**Submission by the United Kingdom for amendments to Document  
TRANS/WP.29/GRRF/1998/19/Rev3 – Draft Regulation for Wheels**

As suggested by the Chairman during the meeting GRRF 50, the United Kingdom proposes the following amendments to the document presented by the Expert from Italy and which was the result of discussions principally between Italy and Germany.

Figure 1:  
Wheel inner contour including examples of inside and outside situations.

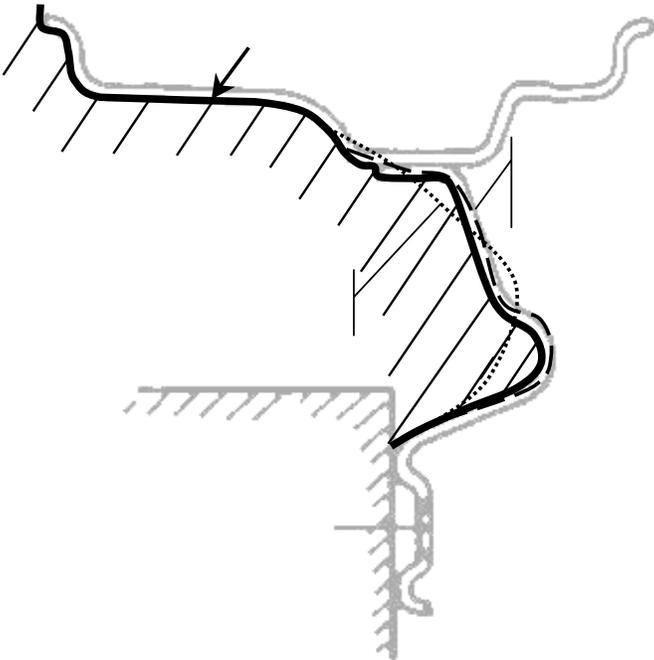
The design of the inner contour of the wheel (wheel calliper, see part I, paragraph 2.11., part II figure 1) must provide sufficient space for the brake, suspension and steering components.

In the case where the calliper is inside the vehicle manufacturer's replacement wheel calliper, a check shall be carried out of the wheel operating clearance with respect to brake, suspension and steering components and general underbody components, taking into account the effect of wheel balance weights (see annex 1 to this Part, item 1, wheel calliper).
